**ELEVATE HOPE
HOUSE**

RAMSEY, MN

LANDSCAPE PLAN

EX05

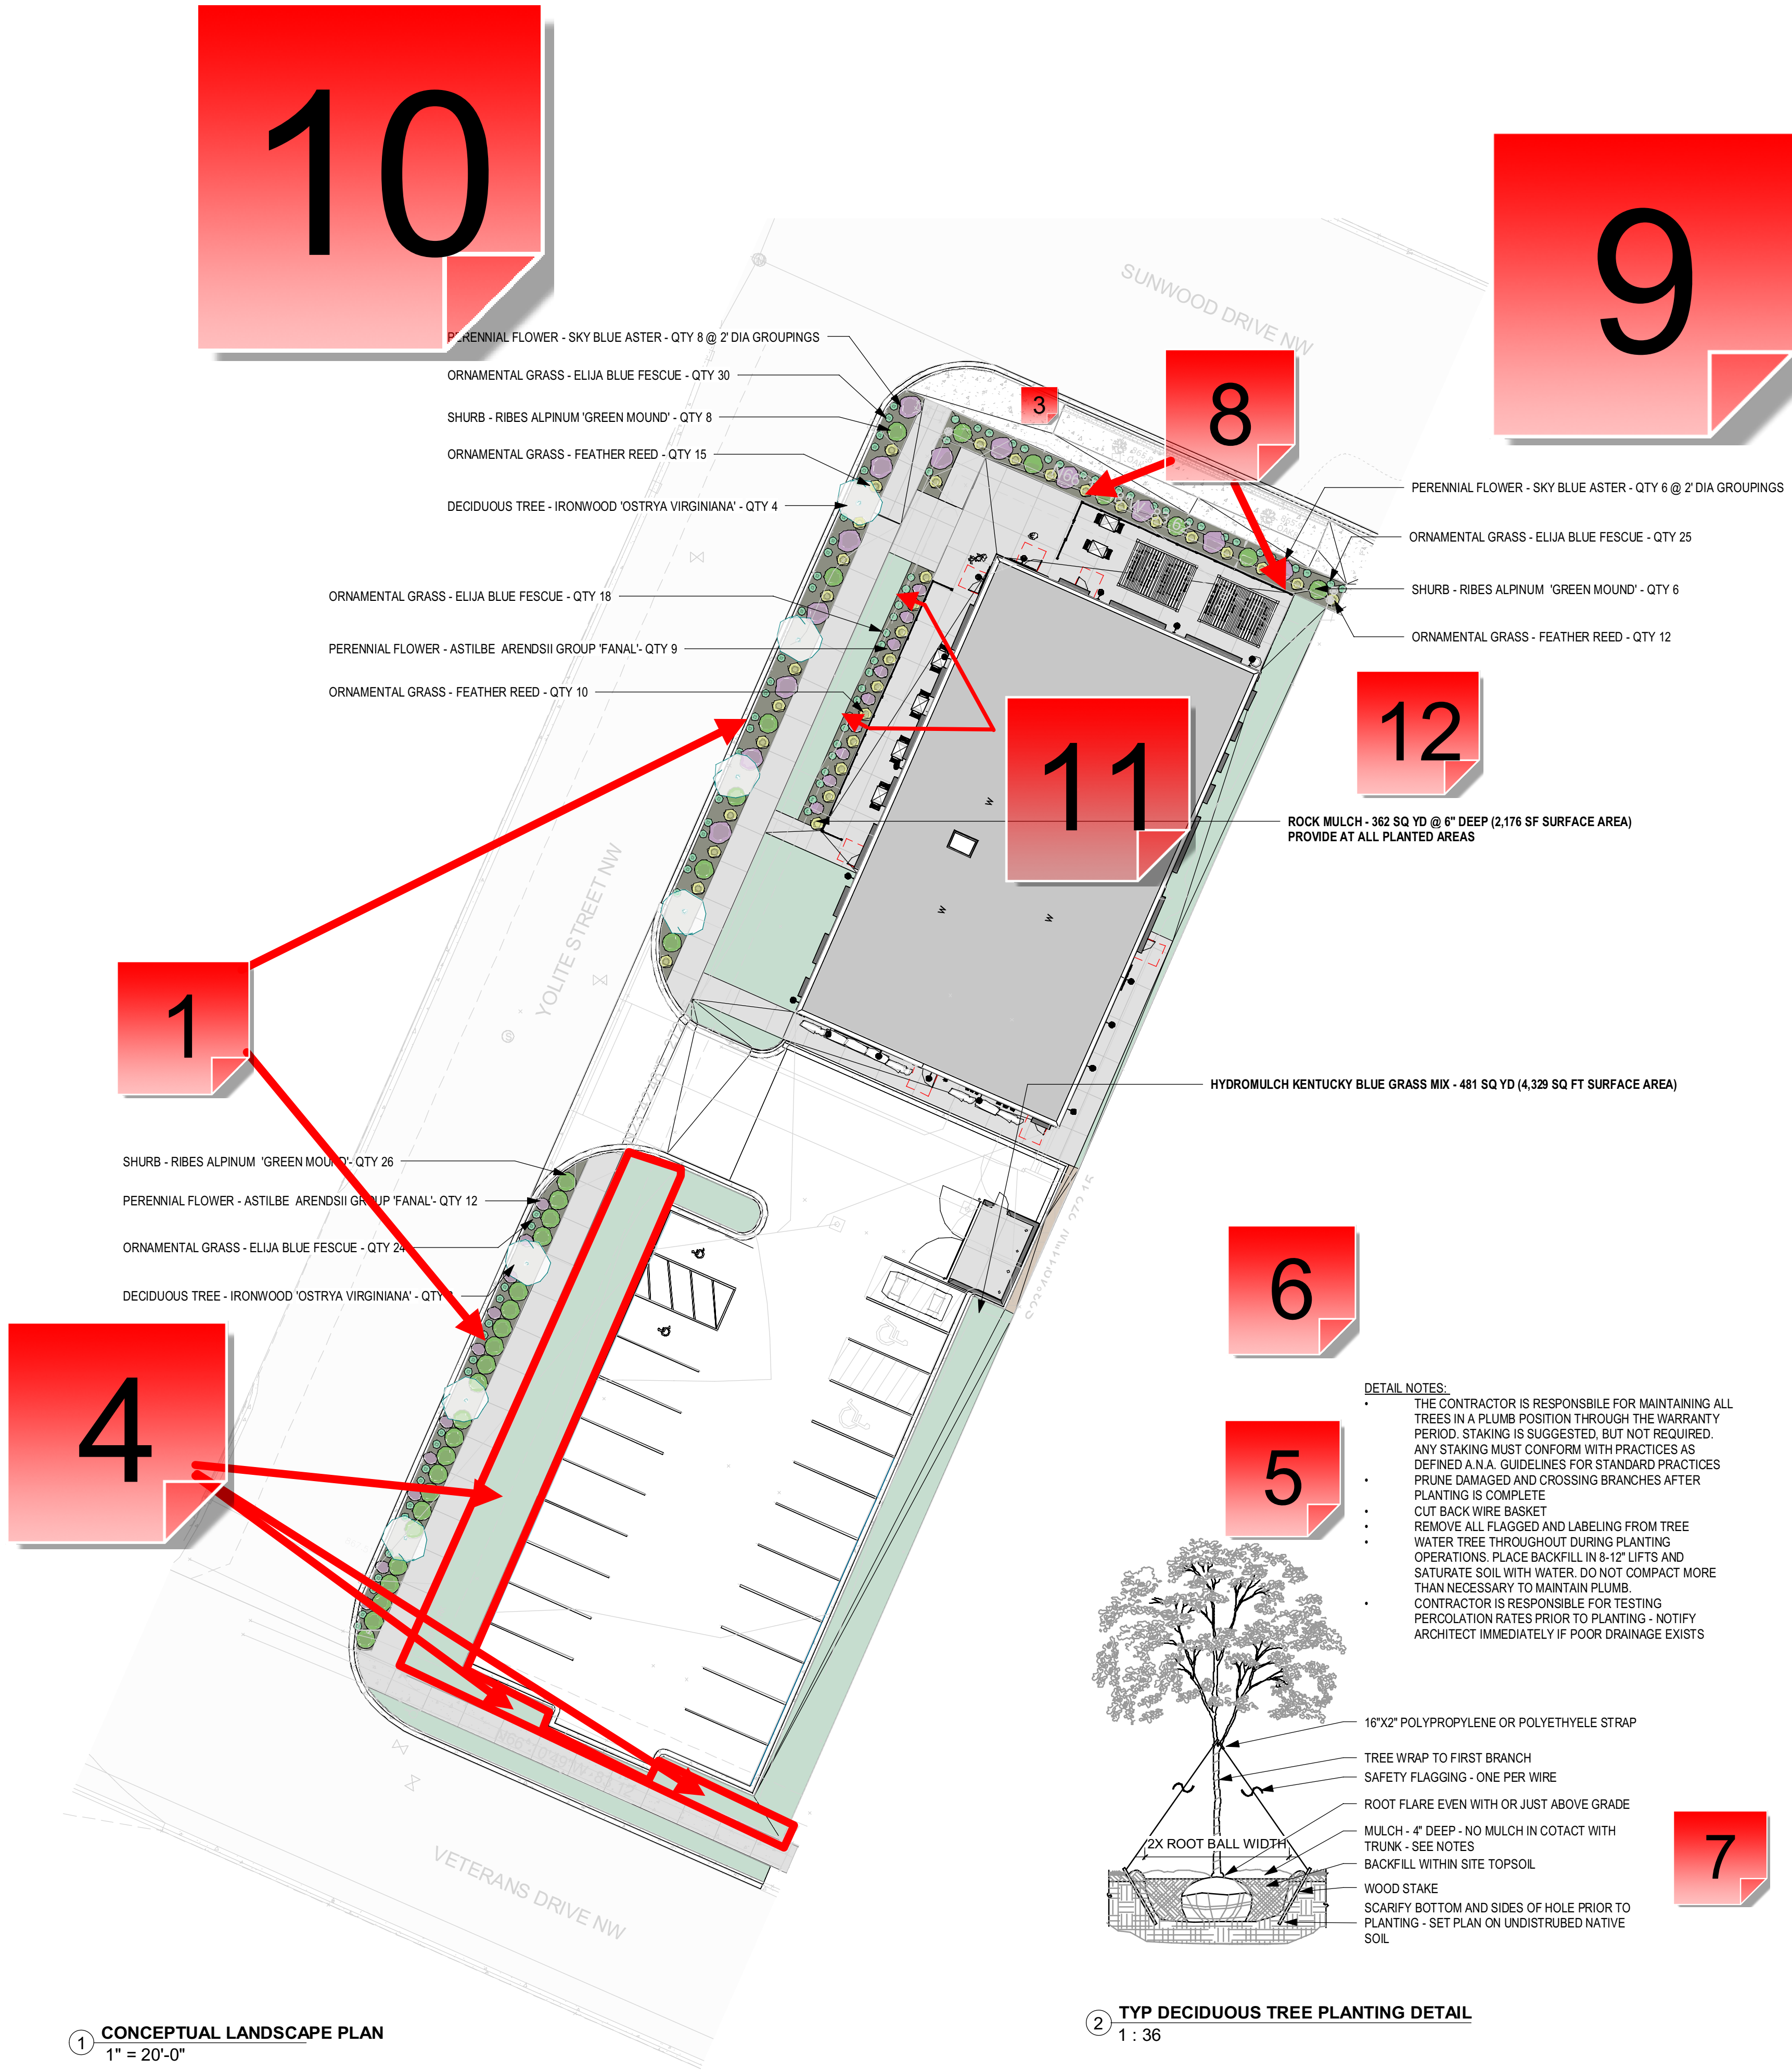
Boulevard installation shall be limited to sod, trees, and irrigation. Perennials and decorative grasses should be shifted to private property, where they could potentially apply toward the required screening of the parking lot from Yolite Street and Veterans Drive.

Ideally, the street trees would be accoldade elms to match what was installed on the west side of Yolite Street. However, Yolite Street does represet a break between subdistricts (COR-2a and COR-1) and per the COR Design Framework, a mix of species would be permitted on the same street when a street crosses into different subdistricts.

Per the COR Design Framework, street furniture should be considered with each proposed development. This seems like it would be an appropriate location for a bike rack.

Per the COR Design Framework, when a surface parking area faces a street frontage, it shall be screened with a decorative wall, ornamental fence, hedge, or some combination thereof, to a minimum height of three (3) feet and a maximum height of 4.5 feet above the parking lot surface.

This should be more clear for the contractor. How much of the wire basket should be cut back? They also need to cut, or at least fold back, the excess burlap. That should be added to this detail.

The trees and shrubs will be subject to a 2-year Landscape Maintenance Guaranty. Please add a Landscape Note stating that the landscape contractor shall warranty the plantings for two years.

For both the Tree Planting Detail and the Shrub Planting Detail, there is language saying "See Notes". Where are these notes? Please make this clearer, maybe specify the plan sheet where the notes can be found?

The proposed perennials and decorative grasses along the north side of the outdoor seating will need to be either relocated or eliminated so that the existing sidewalk east of the site can be extended, at the same width, over to Yolite Street.

Large scale planters should be considered for accent plantings adjacent to the seating area in lieu of the proposed plantings in this strip.

Will irrigation be provided for the plantings and sod? Any proposed irrigation system must include a rain sensor and some form of additional water efficient technology, such as a weather compensating smart controller.

Please add a note specifying that four (4) inches of topsoil, consisting of not more than 35% sand content, shall be applied to all areas not otherwise being improved with impervious surfacing. A

topsoil inspection by the City's Engineering Department is required prior to plantings/seeding being installed.

The COR Design Framework requires that at least 60% of the street frontage be occupied by building facades. This applies to Suwnood Drive, Yolite Street, and Veterans Drive. Outdoor seating with a decorative wall can be used to achieve this. However, the southern portion of the site, south of the driveway along Yolite, and along Veterans Drive, also need some sort of decorative wall, ornamental fence, hedge, or a combination of these elements, to cover a minimum of 60% of these frontages.

Please provide an image or a Detail for the proposed ornamental fence.
